REPORT NO: SY-139R-77
AIRTASK NO: A5345341/0532/7534000001
WORK UNIT NO: A53411-20
DATE: 13 July 1977

COPY NO. 45 **NAVAL AIR TEST CENTER**
REPORT OF TEST RESULTS

Test and Evaluation of AH-1T Forward Ground Handling Gear Assembly (P/N 209-052-244-1);
Second Report (Final)

Figure 2
Brake Assembly

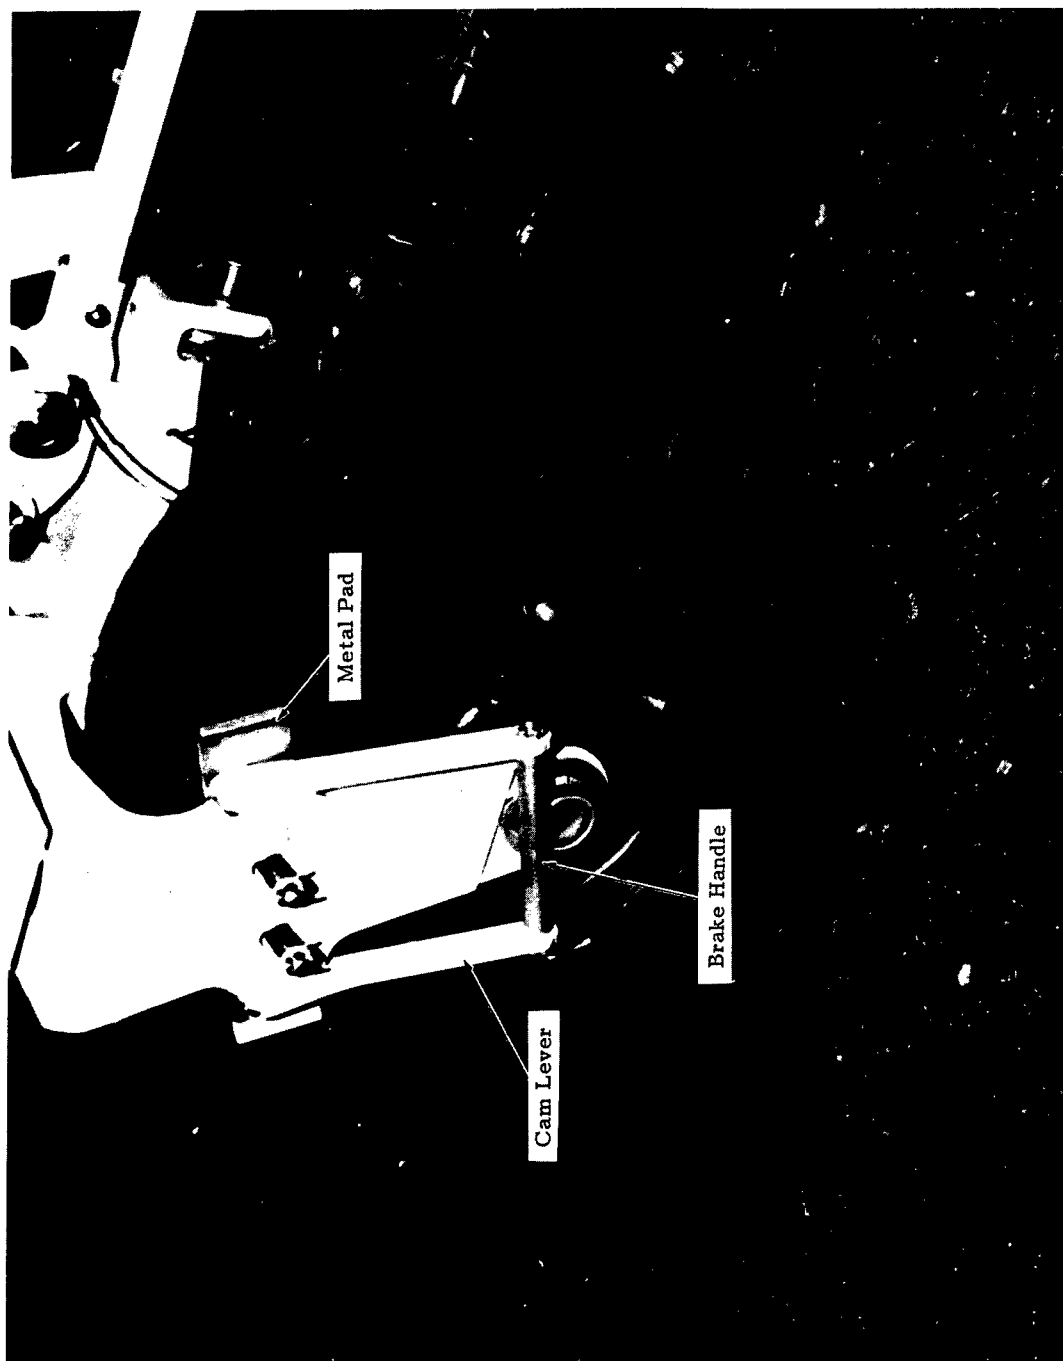
5. The means of stopping tire rotation are inadequate. The brake assembly consists of a cam-lever that contacts a metal pad which then presses against only one side of the pneumatic tire (enclosure (1), figure 2). Applying pressure to only one side of the tire causes tire deflection but does not prevent tire rotation. In addition, there is only one brake on each Gear Assembly which is located on the side of a caster housing. When the aircraft is being moved in one direction, the brake assembly is outboard of the tire. However, when the direction is reversed, the castored wheel rotates 180 deg placing the brake assembly on the inboard side of the tire. This type of brake assembly will result in maintenance personnel not being able to stop the aircraft in an emergency situation. The inadequate means of stopping tire rotation is a Part I deficiency which must be corrected as soon as possible.

6. There is a lack of provisions to prevent the brake assembly handle from being rotated 180 deg through the horizontal position. While the brake is off, the handle is in a vertical down position (enclosure (1), figure 2). To engage the brake, the handle must be pulled up to a horizontal position. Continuing to pull the handle up over center will place it in a vertical up position and will disengage the brake. In the up position, the handle will rest against the upper support of the wheel assembly (enclosure (1) figure 3). Maintenance personnel applying the brake and

14. Inadequate means of stopping tire rotation (paragraph 5).

15. Lack of provisions to prevent the brake assembly handle from being rotated 180 deg through the horizontal position (paragraph 6).

Figure 5
Inserting Quick Release Pin in Gear Assembly Housing

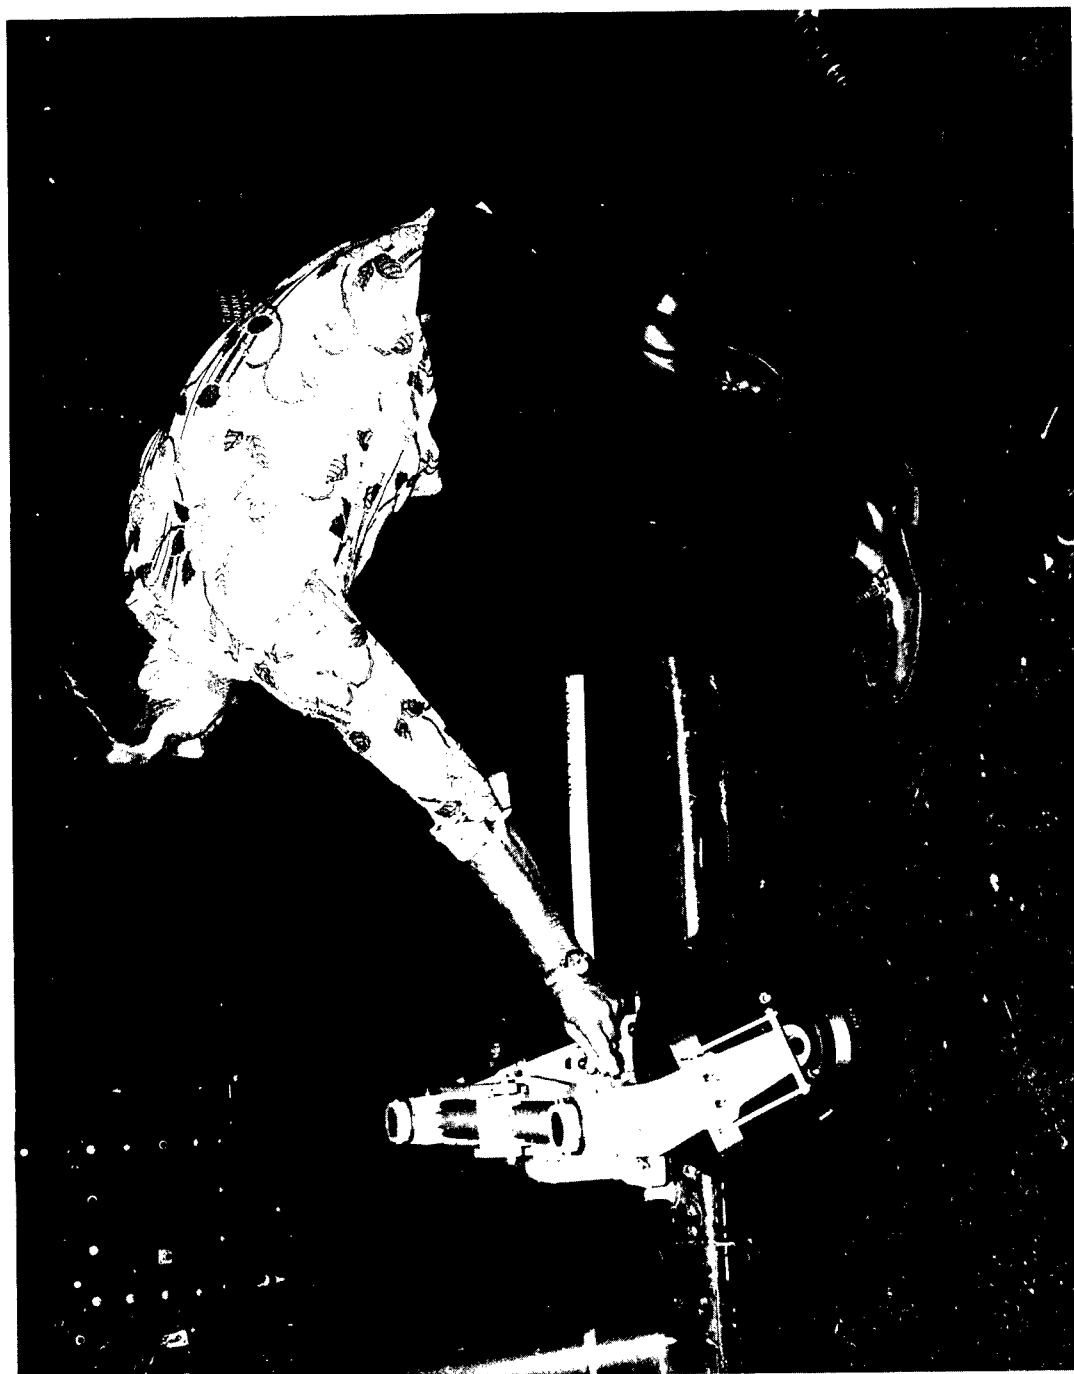
8. The shoulder bushings, in the housing where the quick release pin for securing the lever handle in the down position is inserted in the Gear Assembly, are incorrectly installed and of insufficient length. The two bushings are installed with the shoulders inboard and do not extend to the outer surface of the housings (enclosure (1), figure 6). This results in the quick release pin jamming in the housing. Also, the bushing could be pulled out of the housing by the quick release pin which would result in an abrupt raising of the lever handle and dropping of the aircraft skid. The incorrectly installed and insufficient length of the shoulder bushings constitutes a Part II deficiency which should be corrected as soon as practicable.

9. The length of the wire rope assemblies that secure the two quick release pins to the Gear Assembly is excessive. One quick release pin is used for securing the Gear Assembly to the aircraft skid front lug and the other quick release pin is used for securing the lever handle in the down position (enclosure (1), figure 6). These pins are different lengths and if interchanged will not function satisfactorily. The length of the wire rope assemblies allow either pin to be used for either application which results in a "MURPHY" situation. Also, the quick release pin could be damaged as a result of being caught under the skid while lowering the aircraft. The excessive length of the wire rope assemblies constitutes a Part II deficiency which should be corrected as soon as practicable.

17. Incorrect installation and insufficient length of quick release pin shoulder bushings (paragraph 8).

18. Excessive length of quick release pin wire rope assemblies (paragraph 9).

Figure 6
Quick Release Pin Housing

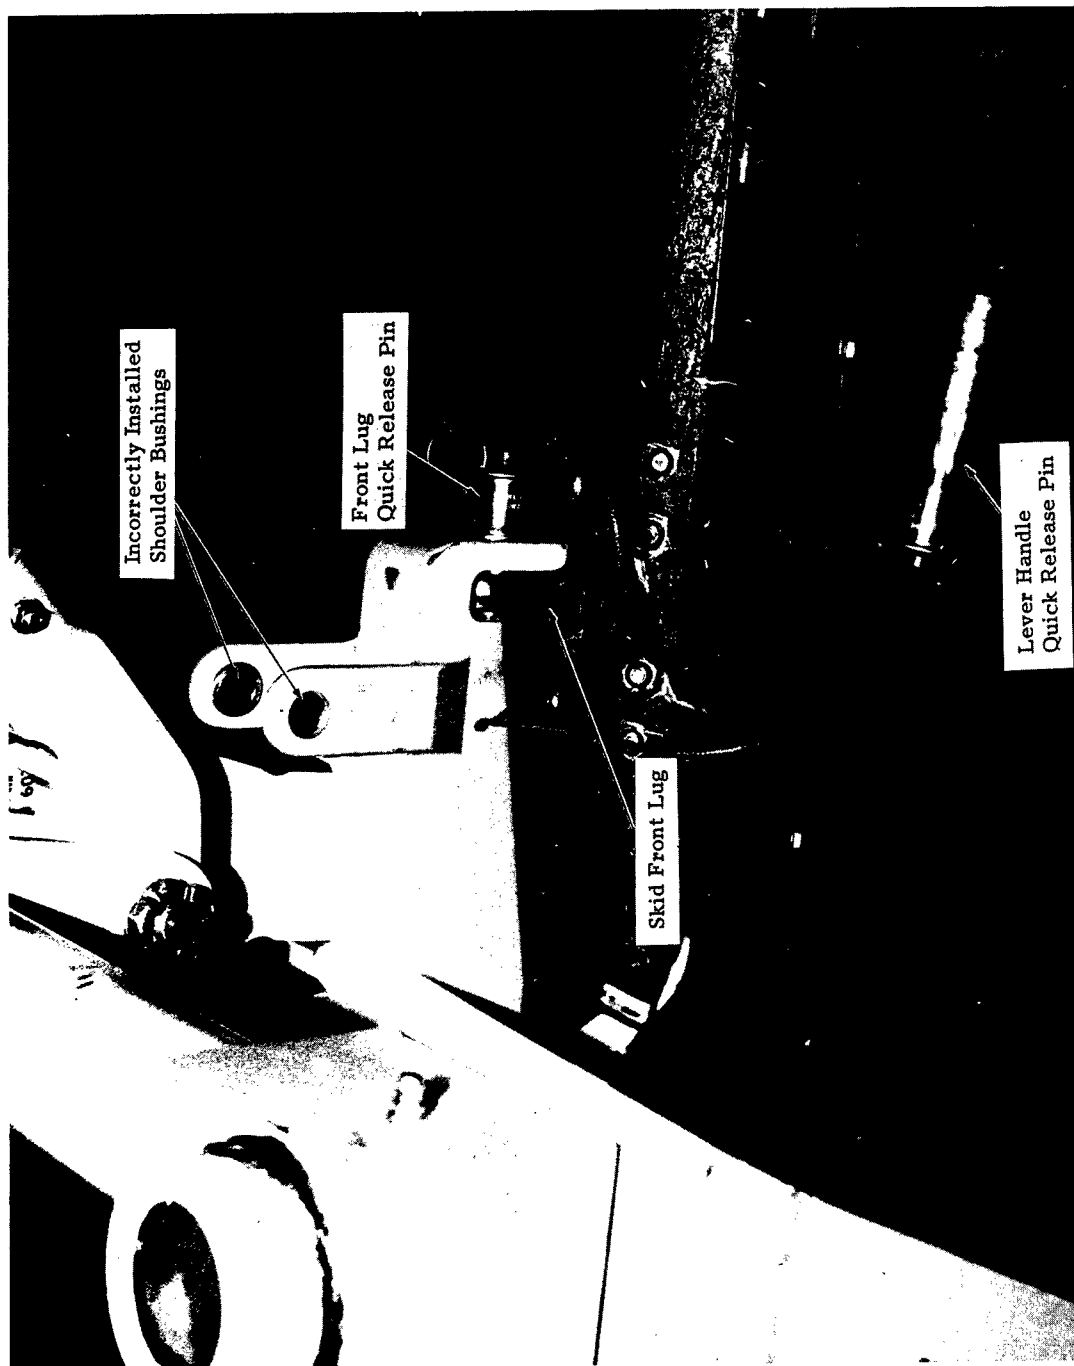
10. There is a lack of support for both ends of quick release pin. The forward attachment point for securing the Gear Assembly to the aircraft skid (enclosure (1), figure 6) consists of a bushed hole in the gear housing. A quick release pin is inserted through the bushed hole and a hole in the aircraft skid front lug. The aircraft weight is exerted on the quick release pin which is not supported at both ends and results in a bending moment being applied to the quick release pin. Failure to support the quick release pin at both ends so that a shear load is applied to the pin will cause excessive bushing wear and pin deformation which will result in the inability to secure the wheel assembly to the aircraft. The lack of support for both ends of the quick release pin is a Part II deficiency which should be corrected as soon as practicable.

19. Lack of support for both ends of the forward attachment point quick release pin (paragraph 10).
